# HANDEE HUGOS #98 SP-72-2015

# Certified Action of the City of Raleigh Planning Commission

**Case File / Name:** SP-72-15 / Handee Hugo's #98

Site Plan

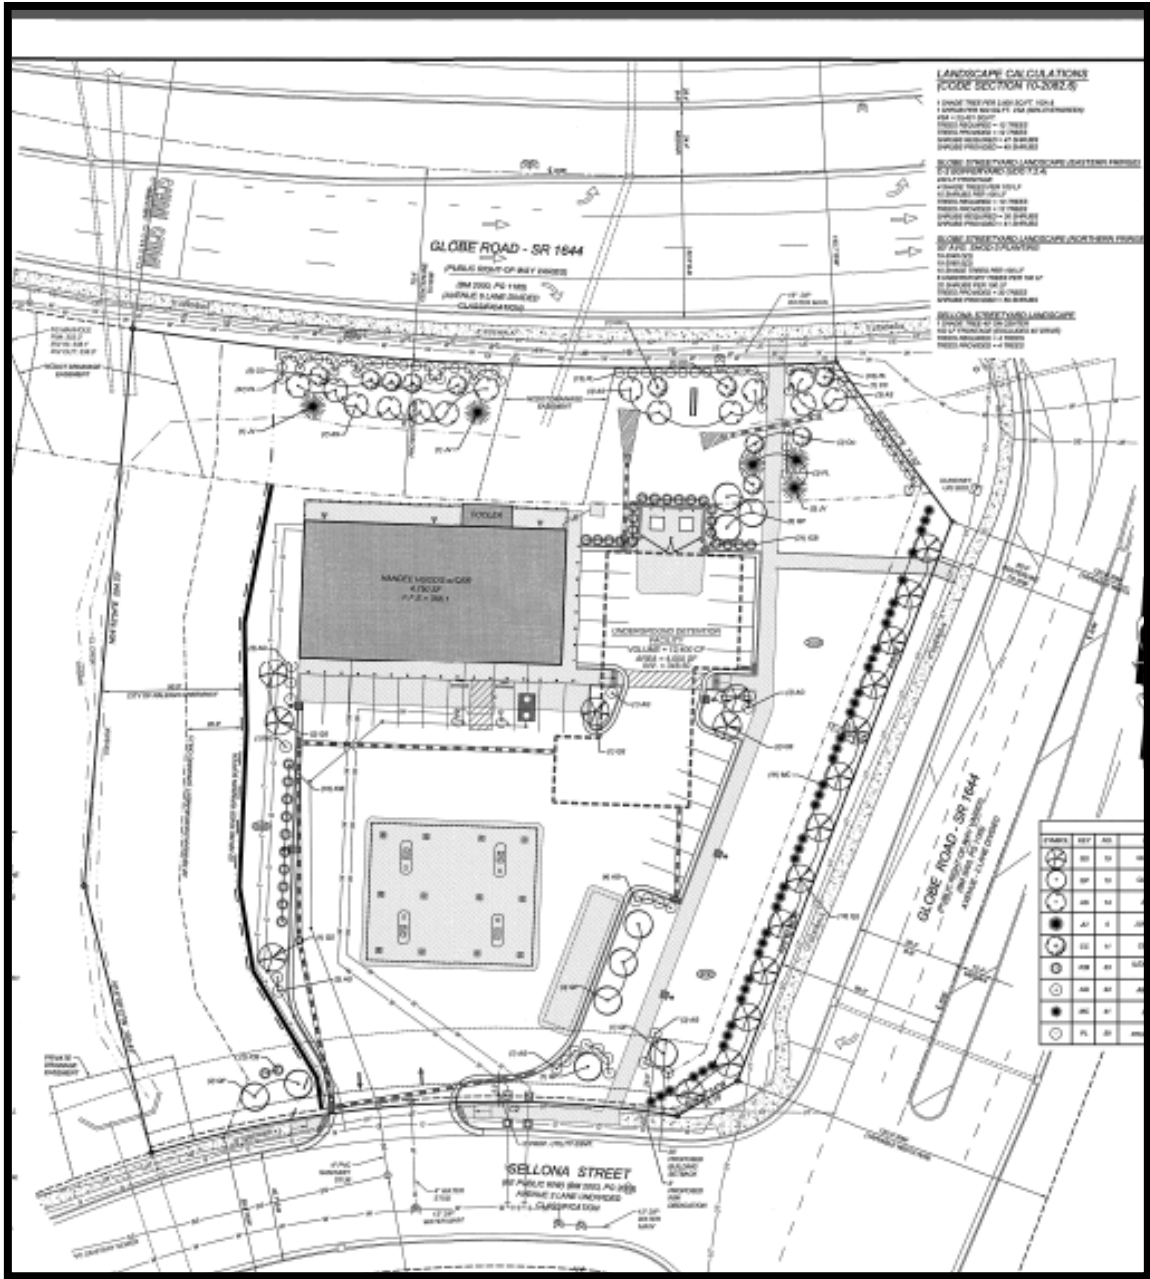
- (1) That the Planning Commission finds that this site plan meets the standards for approval of Code Section 10-2132.2(d);

- (2) That a tree protection fence must be located in the field for the protection of the 50' Neuse Riparian Buffer and the 50' natural protective yard and fence is to be inspected by the Conservation Forester. That a tree removal permit is issued for the grading and tree removal within the natural protective yard which shall not exceed 30%;

- (6) That flood prone areas, as approved by the City Stormwater Engineer, are shown on the preliminary plan and shall be shown on the recorded map;
- (7) That compliance shall be shown with bulk lot coverage limitations of 50% of the flood fringe on the lot. The approved preliminary plans indicates 46% bulk lot coverage (fill);

- (13) That 2' of right-of-way along Sellona Street is dedicated to the City of Raleigh and a copy of the recorded plat be provided to the City prior to building permit issuance;

- (14) That a fee-in-lieu be paid for 1' sidewalk along Globe Road at Brier Creek Parkway, Globe Road, and Sellona Street;
- (15) That an encroachment agreement from NCDOT for sidewalk improvements within the right-of-way along Globe Road at Brier Creek Parkway will be required;
